8 April 2025

Our Ref: 2562-21

RESPONSE TO FURTHER INFORMATION REQUEST APP-20242608 – WAIKAKA GOLD MINES LIMITED

Figure 1 Area bounded by grid coordinates identified in response to questions 13.

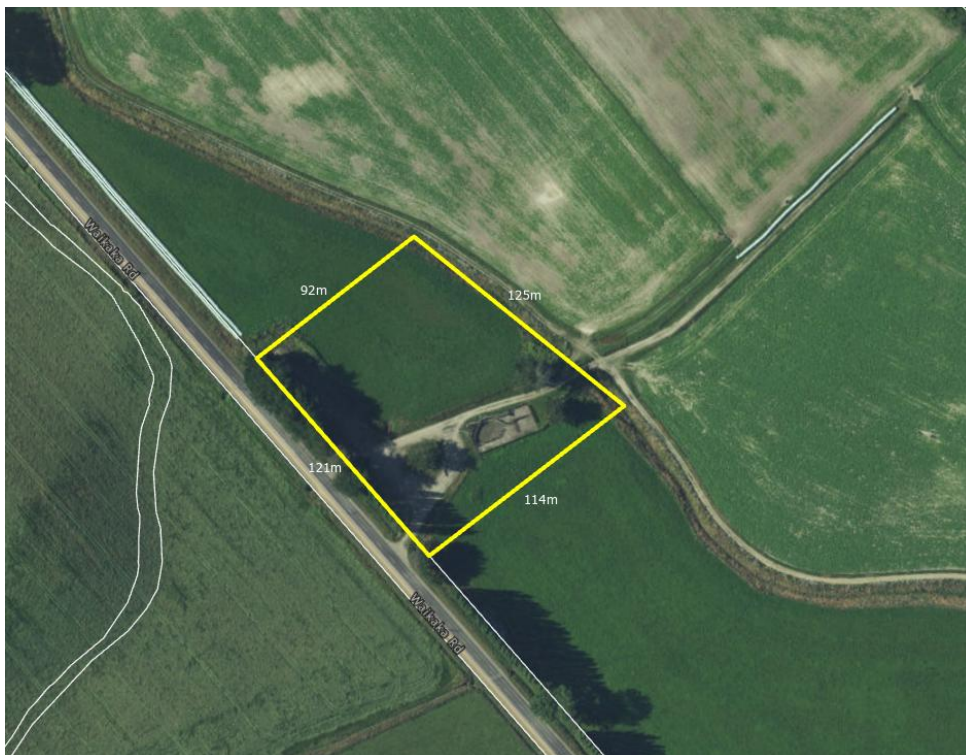
13. Contaminated land (question 13)

The area in question falls within the extent of the proposed mine pit. While the PSI considered agricultural land uses, the report confirms that specific soil sampling of that location has not been undertaken. To that end we propose conditions that provide for sampling and appropriate management of soils prior to the commencement of earthworks in that area. Suggested drafting of such a condition follows:

Prior to the commencement of earthworks within the area bounded by the following map coordinates:

North - 169.0000894°E 45.9488537°S
East - 169.0013425°E 45.9495540°S
West - 168.9991484°E 45.9493565°S
South - 169.0001806°E 45.9501748°S

The Consent Holder must submit a Detailed Site Investigation (DSI) and Site Management Plan (SMP) prepared by a Suitably Qualified and Experienced Practitioner (SQEP). An SMP is not required if the SQEP advises that, based on the results of the DSI, soil contamination does not exceed the applicable standard.

The area identified by the above grid coordinates is shown in **Figure 1** below.
